Access Compliance Report

Public Rights-of-Way

| Intersection ID: 43482 | Main Street: SAFARI_CT | Cross Street: ERWIN_RD | Location: NE |
| ADA ID: B4DFA08B511D | Ramp Type: Perp | Initial Pass/Fail: Fail | Overall Compliance: No |

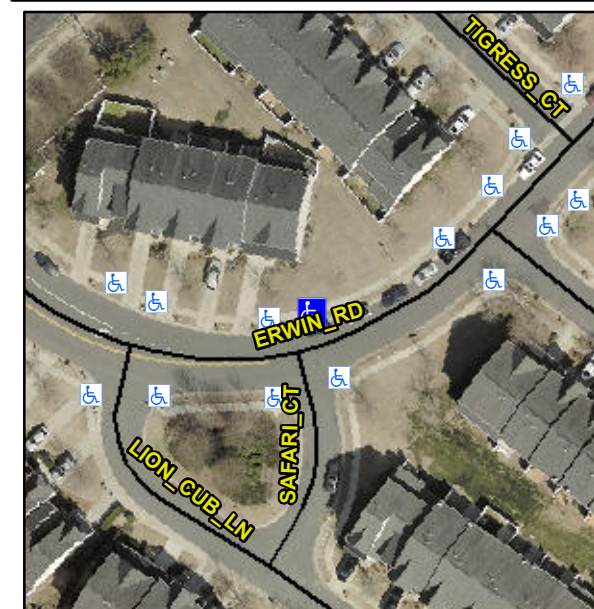
Not Found, R304.2.2, R304.5.3

| Compliance | Description | Data | Compliance | Description | Data |
|------------|-----------------------|------|------------|-----------------------------|------|
| N/A | Ramp Length (in) | 48.0 | No | Ramp Slope (%) | 9.8 |
| Yes | Ramp Width (in) | 48.0 | No | Ramp XSlope (%) | 5.1 |

Remove & Replace Entire Ramp.
